PRELIMINARY AND FINAL DRAINAGE PLAN AND REPORT FALCON STORAGE SUBDIVISION

PCD File No. PPR2232
PCD File No. MS232

SUBJECT: Preliminary and Final Drainage Plan and Report
Falcon Storage Subdivision

O-1

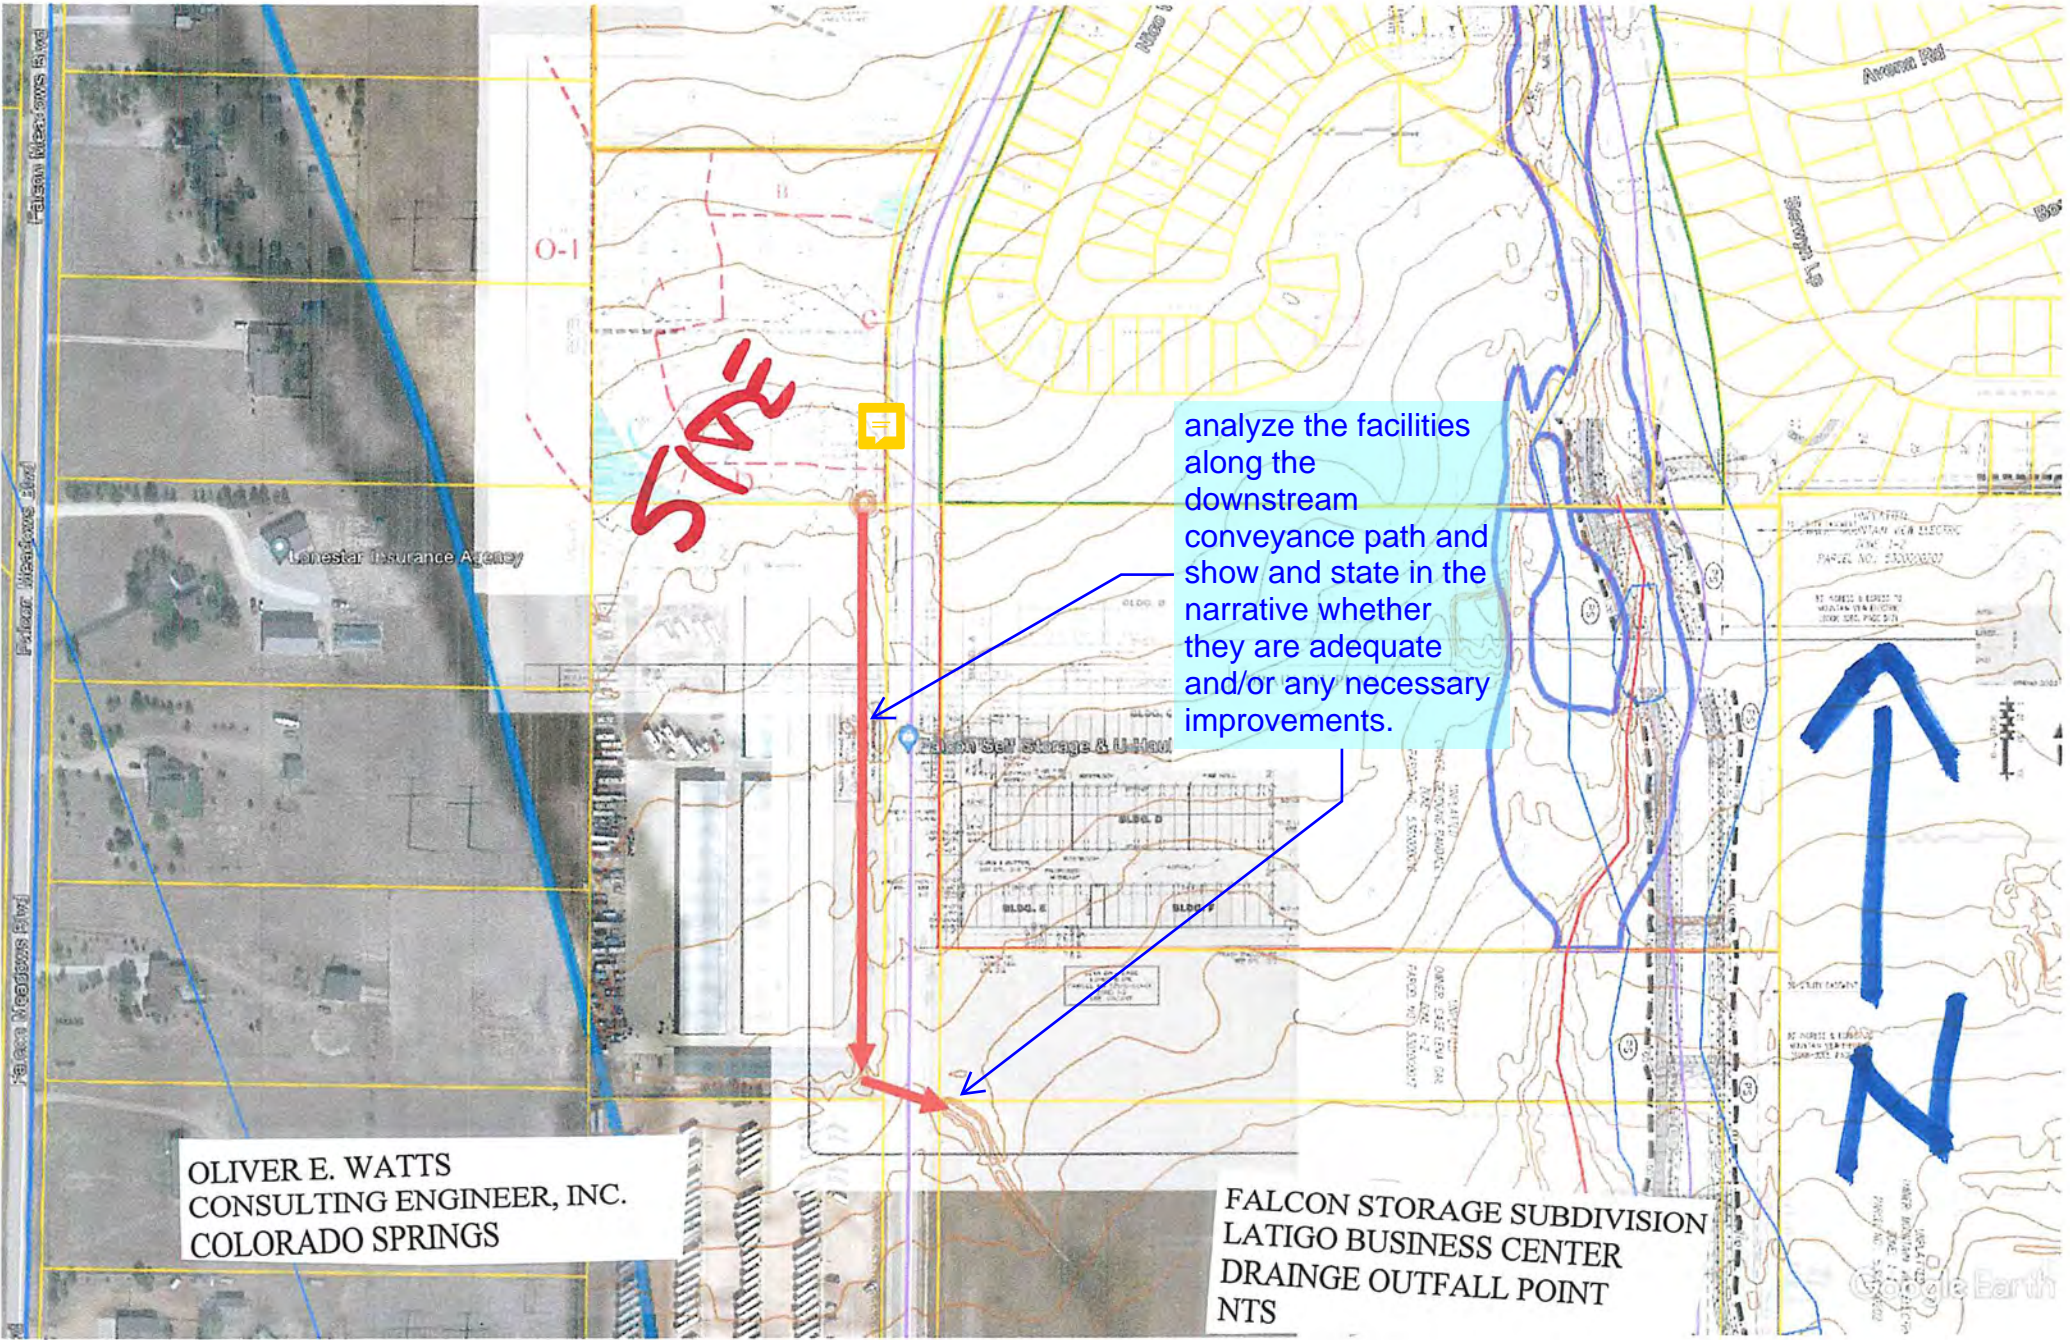
analyze the facilities
along the
downstream
conveyance path and
show and state in the
narrative whether
they are adequate
and/or any necessary
improvements.

PCD PROJECT NO: PPR2232 & MS232
SHT. NO.
DRAINAGE PLAN
1 OF 1

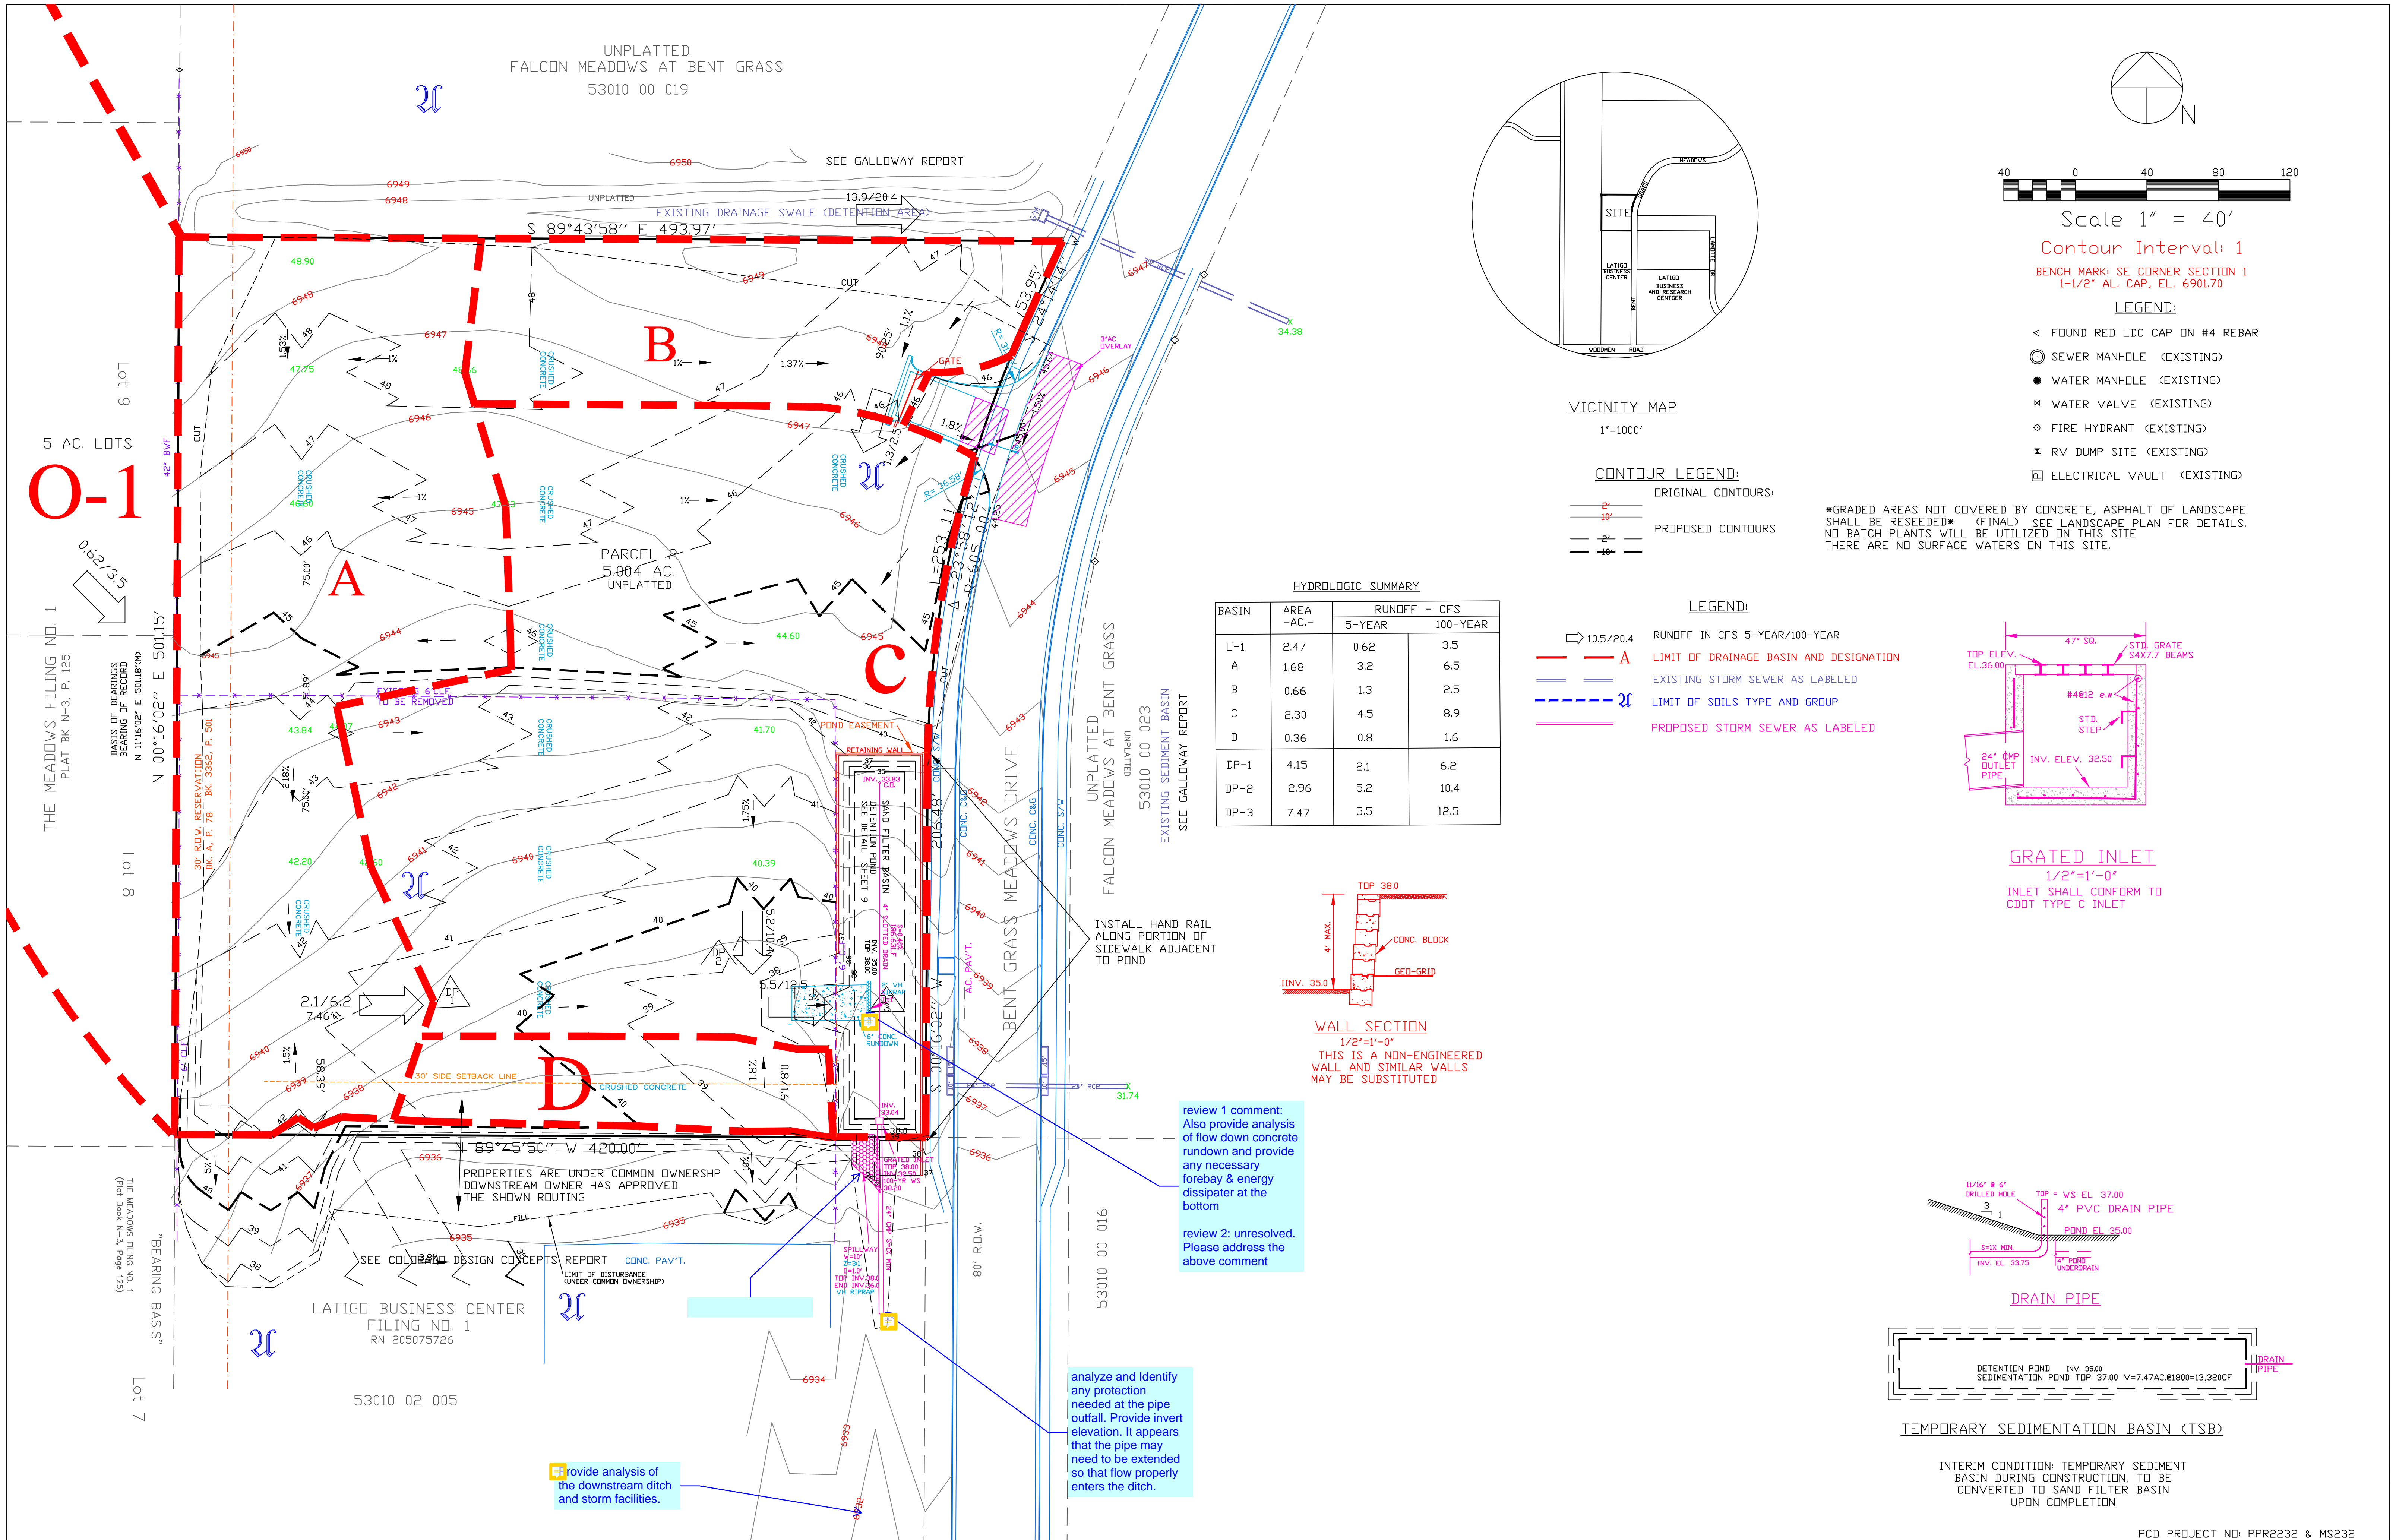
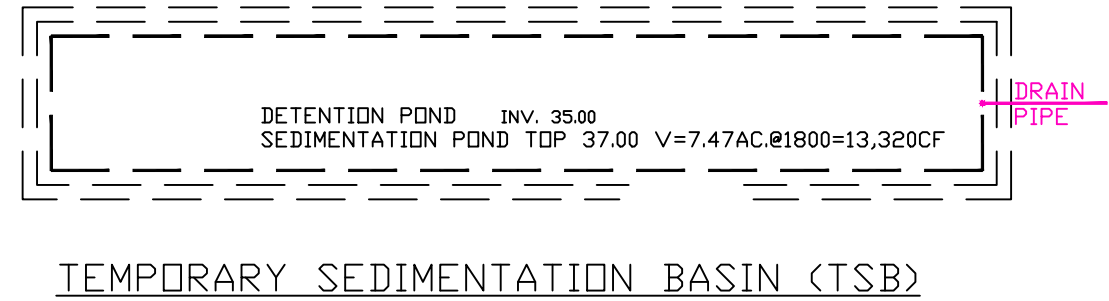
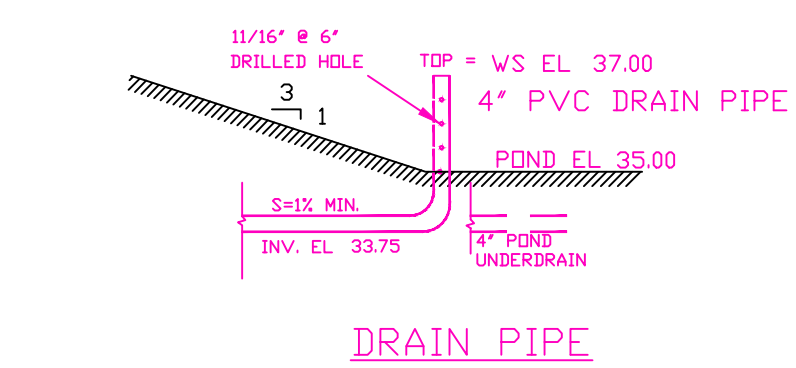
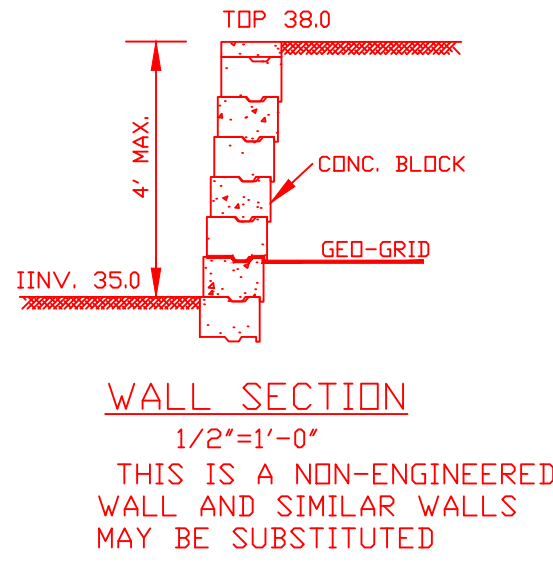
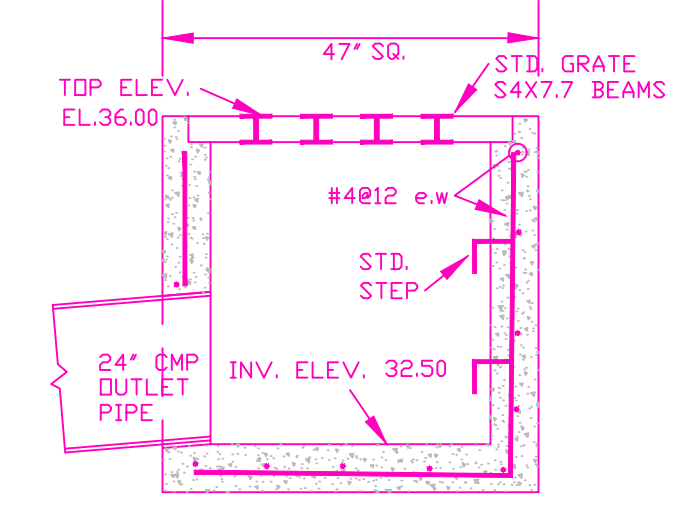
review 1 comment:
Also provide analysis of flow down concrete rundown and provide any necessary forebay & energy dissipater at the bottom

review 2: unresolved.
Please address the above comment

analyze and identify any protection needed at the pipe outfall. Provide invert elevation. It appears that the pipe may need to be extended so that flow properly enters the ditch.

provide analysis of the downstream ditch and storm facilities.
